# Longfield Solar Farm Draft position statement on Landscape and Visual Impact

Prepared for: Essex County Council,  
Chelmsford City Council, Braintree District  
Council

14<sup>th</sup> July 2022

Cumulative Development Plan

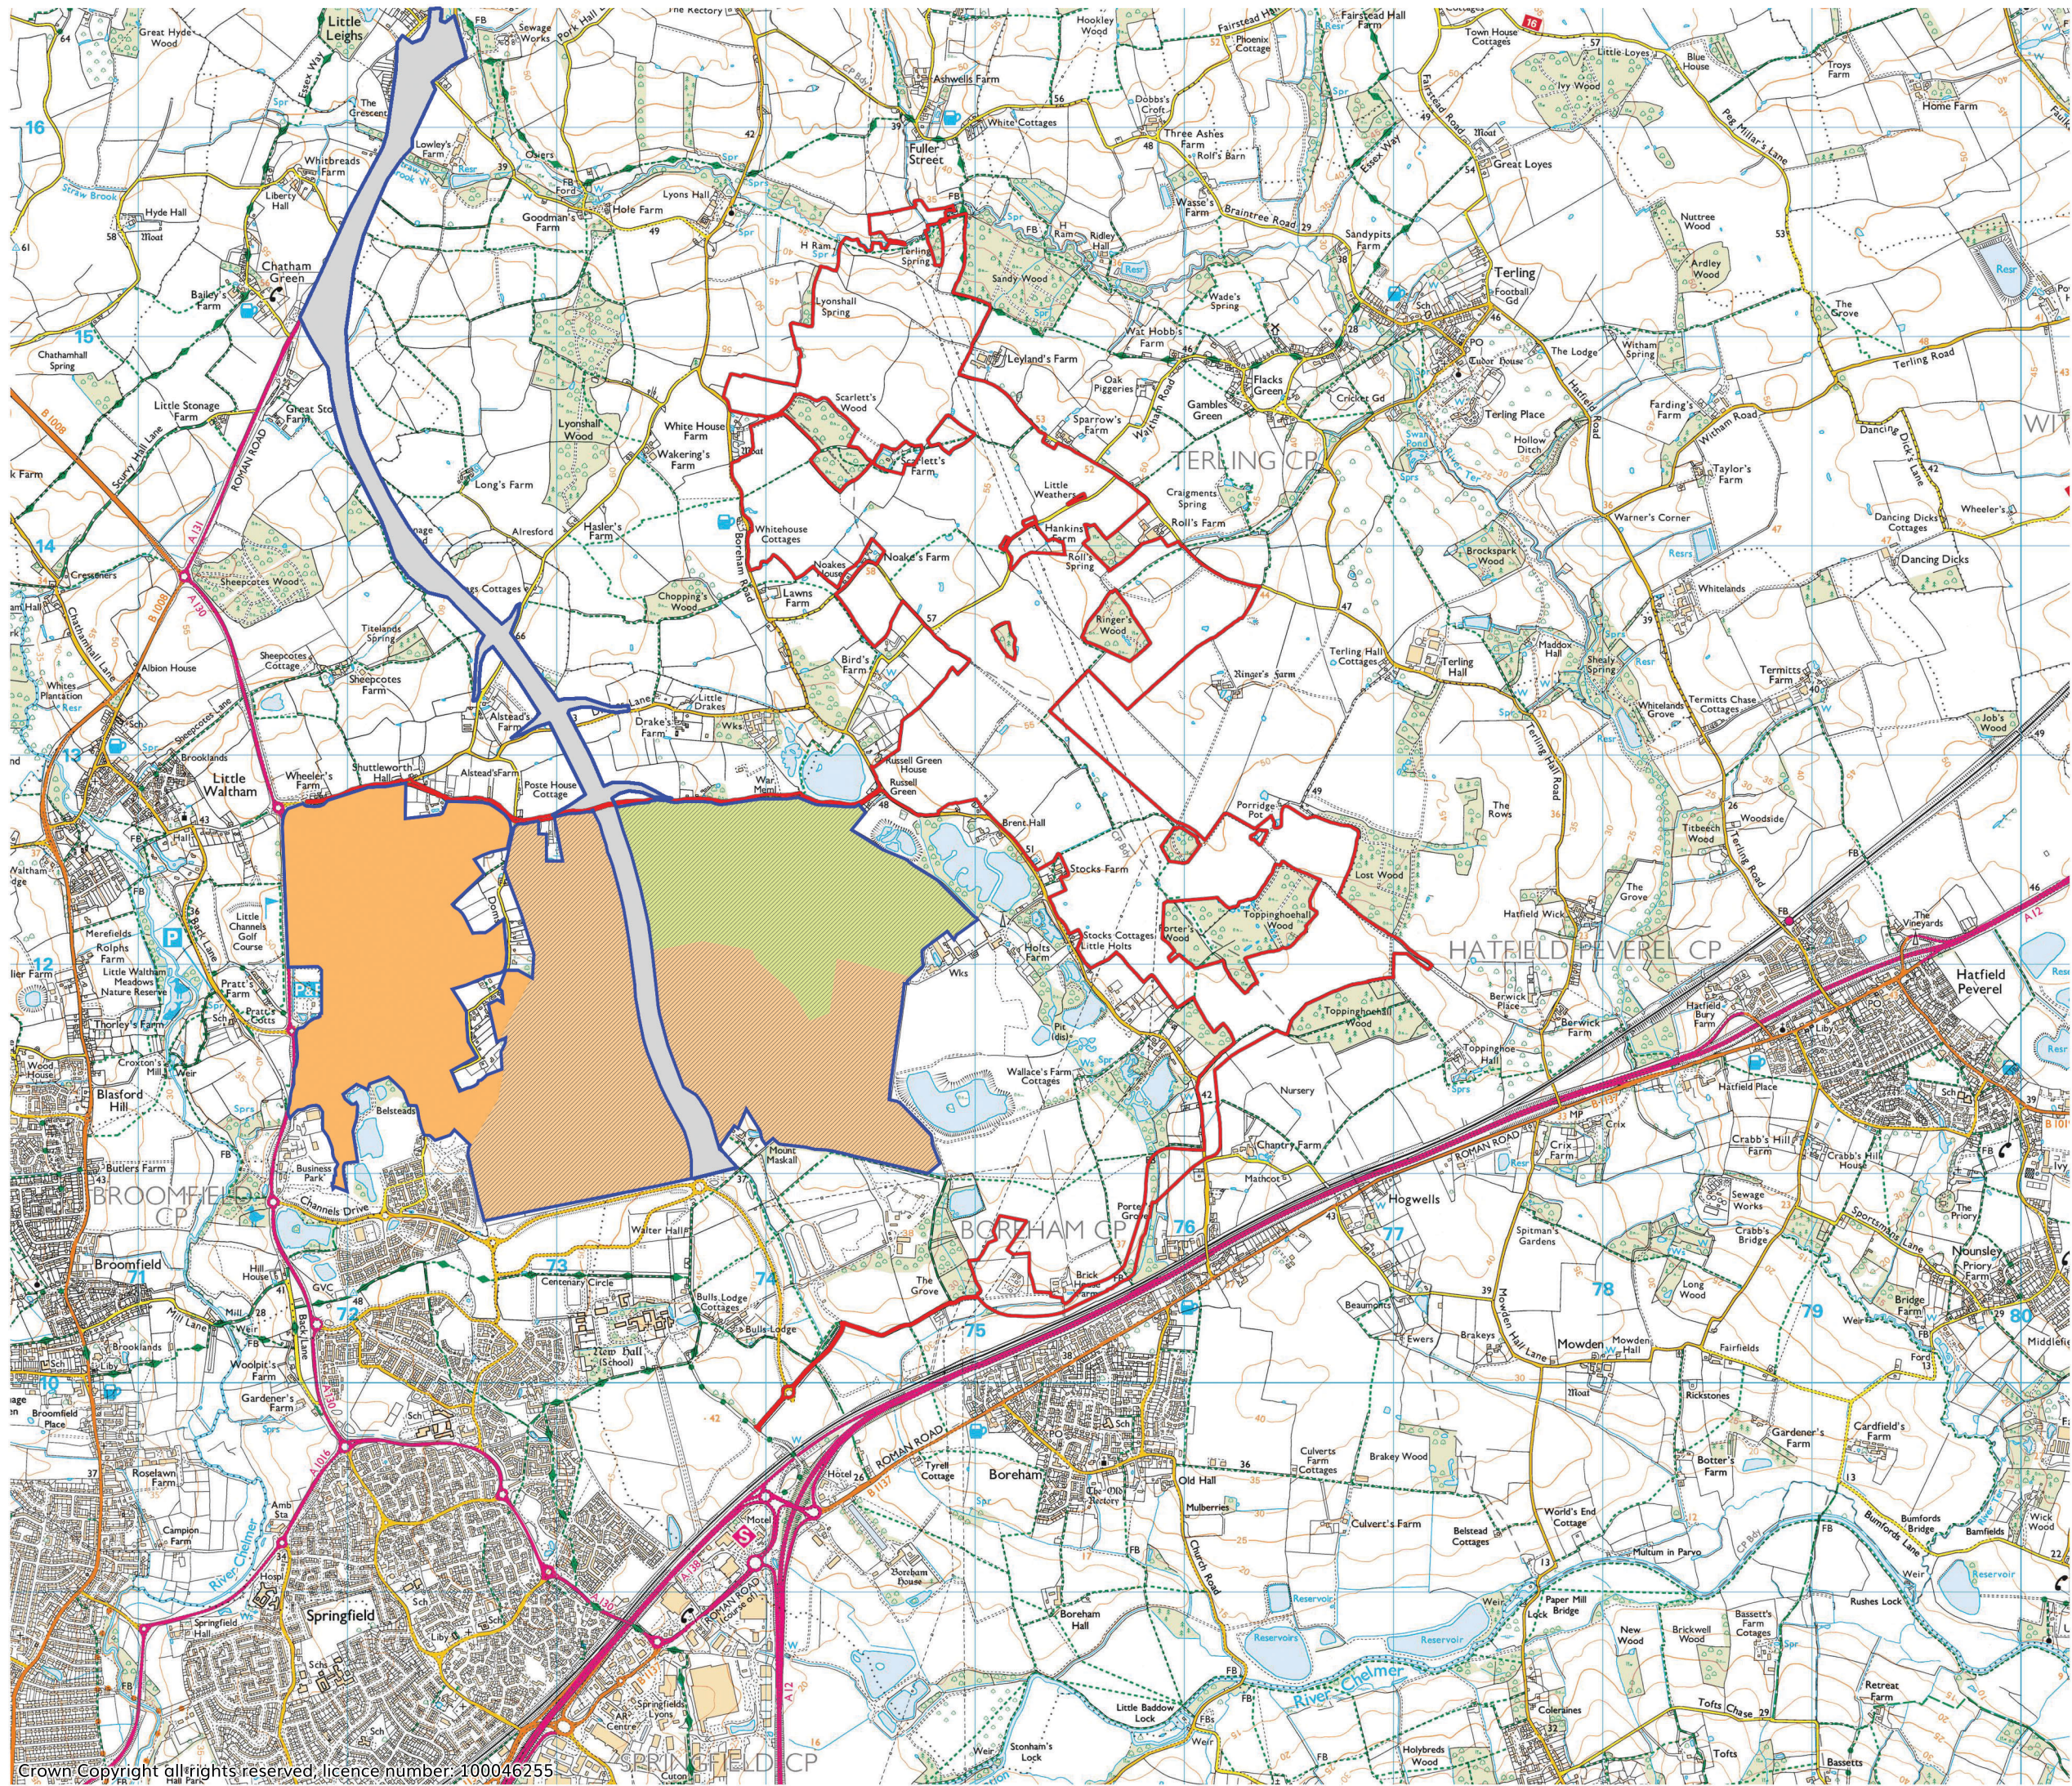
The ES falls short of describing the combined cumulative effect across the two District LCAs and spatially mapping of the Chelmsford North-Eastern Urban Extension and other developments in combination with the Longfield proposal.

When the major developments of the North-eastern Urban extension to Chelmsford, the Chelmsford Garden Village and the Chelmsford Northern By-pass and Longfield are mapped it is clear that if all developments went ahead there will be an erosion of the countryside buffer between Chelmsford and Terling. Assessment of the impact of the proposed major developments will only be undertaken at the time that they come forward as part of the planning process, however, it is likely that any assessment would find adverse impacts from the development of open countryside to a major housing scheme or new infrastructure project. When combined with Longfield's effect on the Terling Farmland plateau the cumulative effect is likely to be a moderate adverse effect on the two character areas.
